ADDENDUM NO. 2

RFB #8496 Outfall Switchgear Replacement Project

This Addendum No. 2 shall be incorporated into and made part of the above referenced contract documents for RFB #8496.

SACRAMENTO REGIONAL WASTEWATER TREATMENT PLANT
X09 OUTFALL SWITCHGEAR REPLACEMENT PROJECT

ELECTRICAL
INTERIM SWITCHGEAR ELECTRICAL SITE PLAN

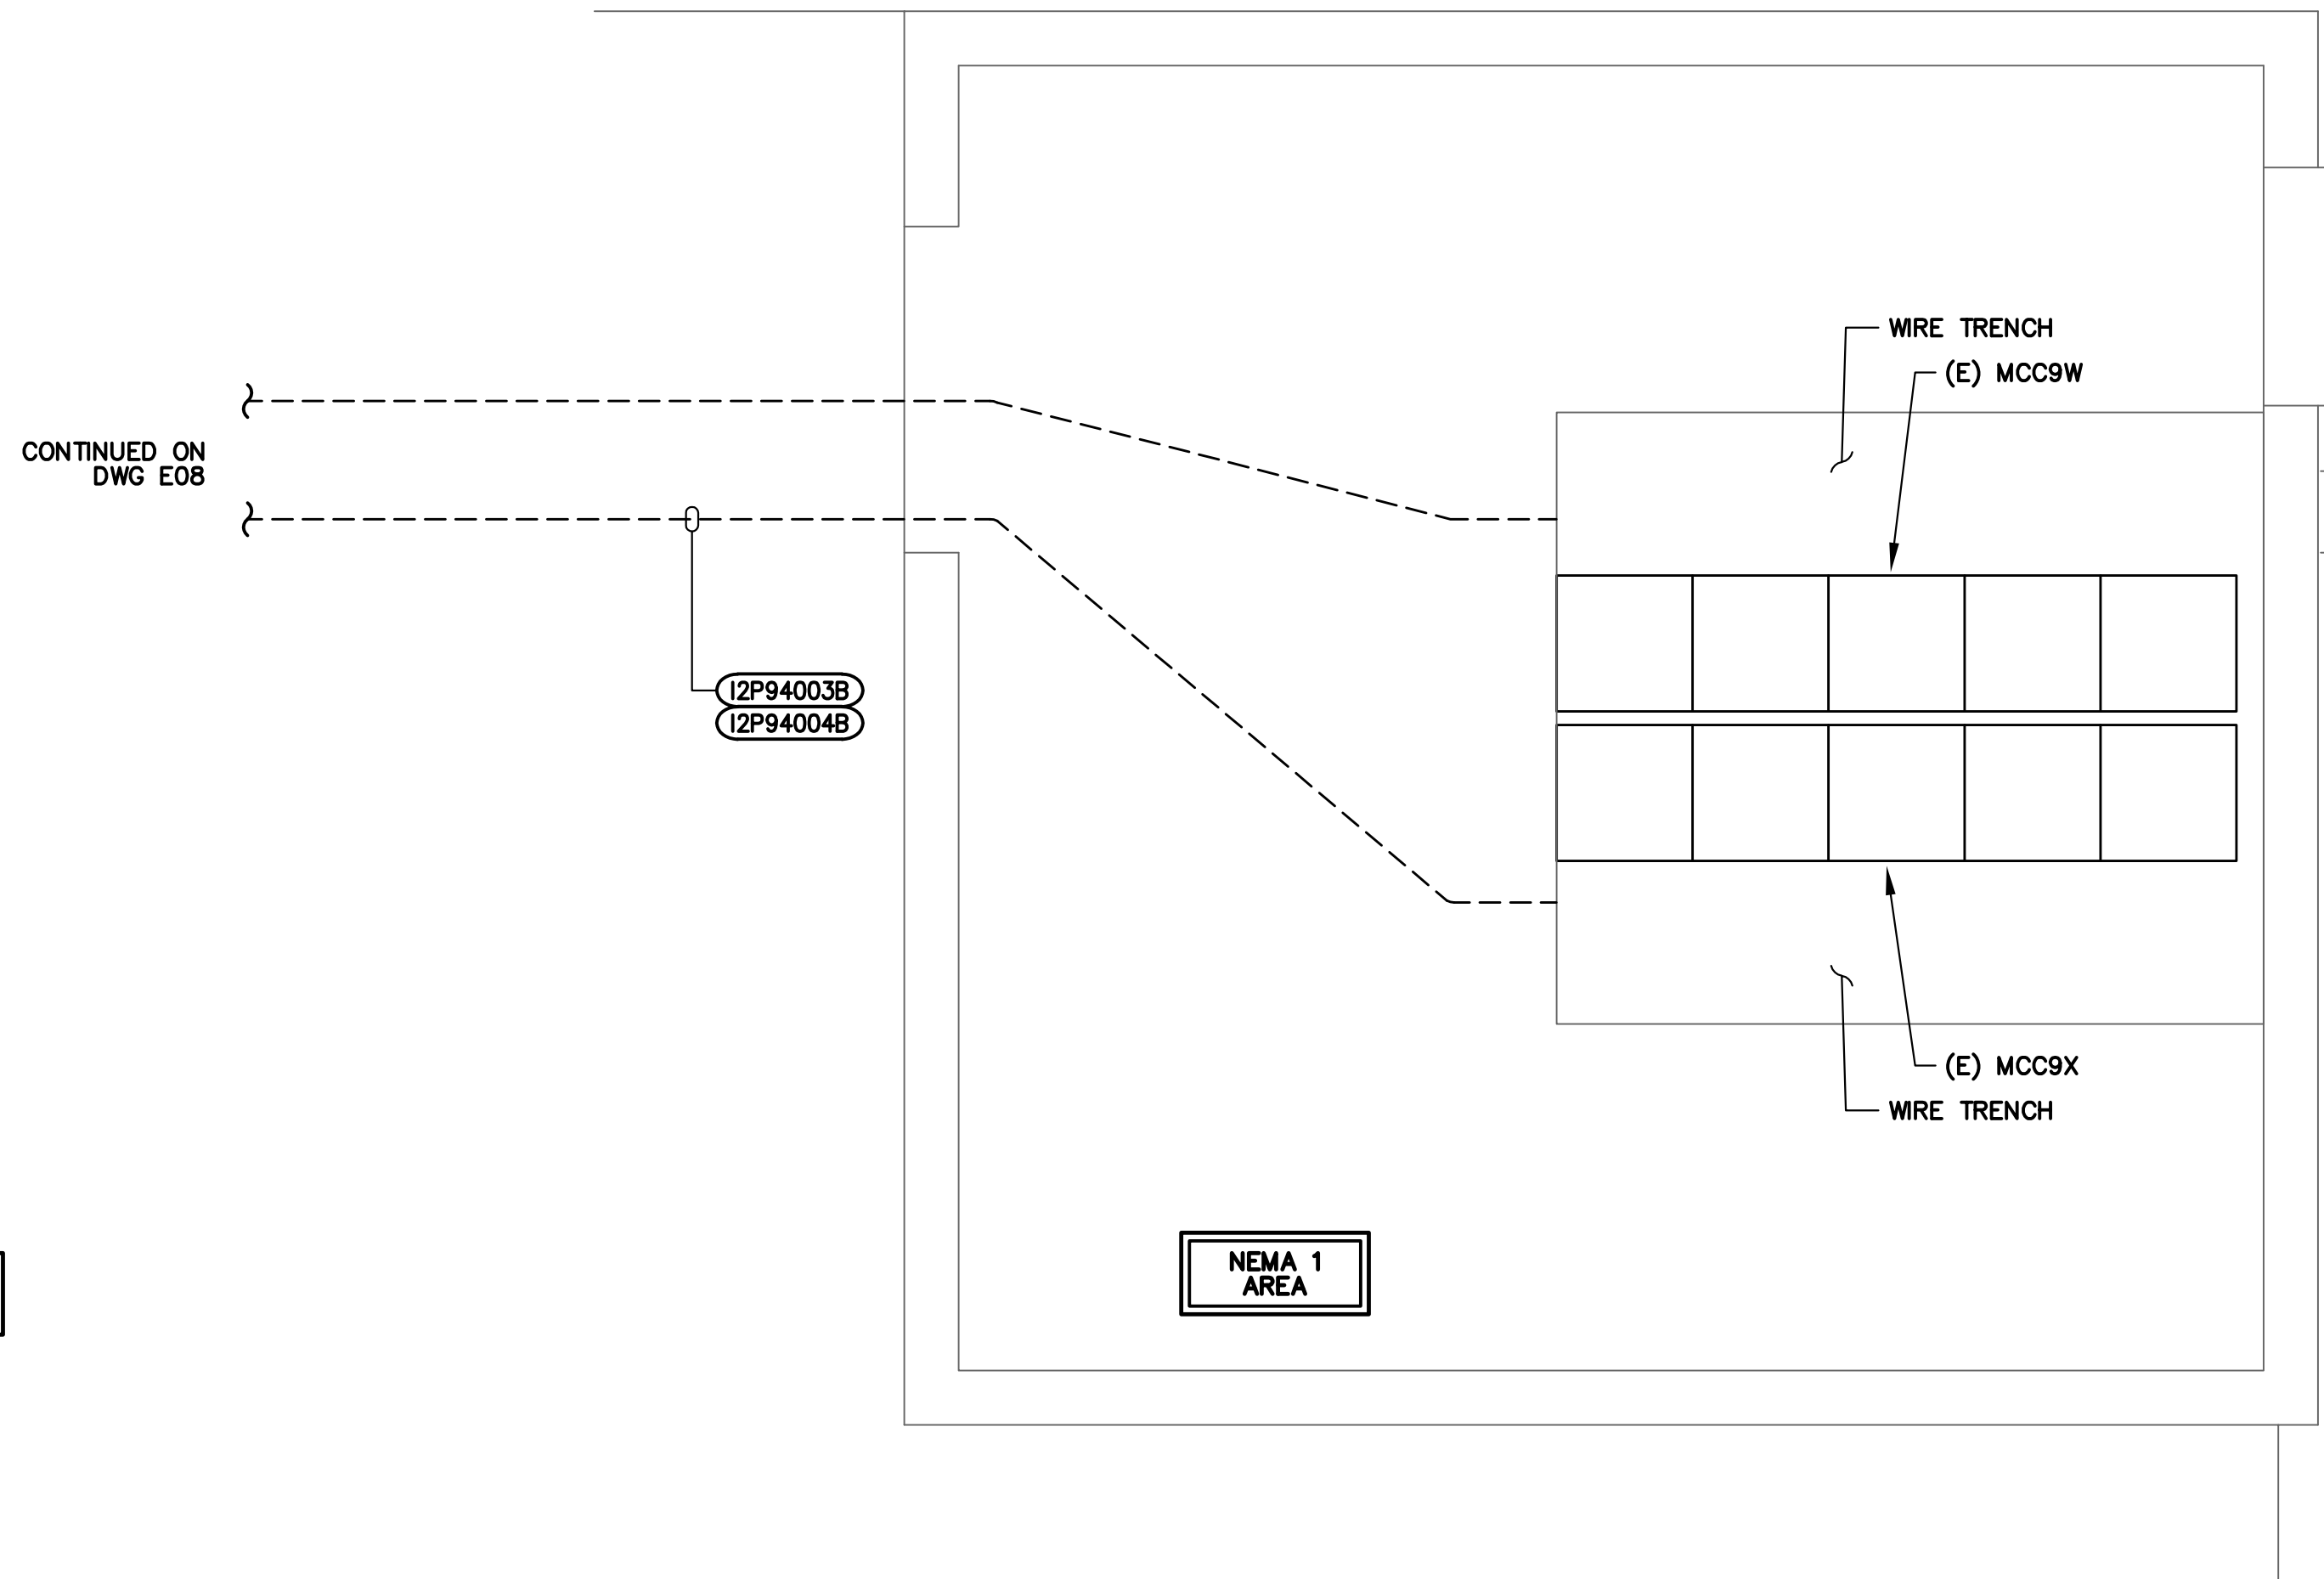
1. SPLICE INTERIM CABLES TO EXISTING #350 CABLES IN POWER PULLBOX FOR INTERIM SOLUTION.
2. ROUTE NEW INTERIM CABLES THROUGH EXISTING JUNCTION BOXES TO WIRE TRENCH AND TERMINATE AT LOAD.
3. LOCATE SWITCHBOARD ON OVERSIZED 4" RAISED WOOD PALLET WITH CABLES CONNECTED THROUGH BOTTOM. LAG ANCHOR SWITCHBOARD TO PALLET, WEDGE ANCHOR PALLET TO PAVEMENT.
4. REMOVE EXISTING CABLES TO SWITCHGEAR AND CONNECT WIRING FROM TRANSFORMER OUTPUT TO INTERIM MAIN SWITCHBOARD.
5. ONLY CONDUITS PERTAINING TO THIS PROJECT LABELED OR SHOWN.
6. CABLE TYPE "DLO" (TYP) IS 2000V RATED, EPDM INSULATION, CPE JACKET, TYPE K STRANDING, SUPER FLEXIBLE CABLE.

Please identify which conduits are to be new, and which ones are existing on sheet E05/E06. Currently everything on this sheet looks like it should be new. Notes are confusing at best.
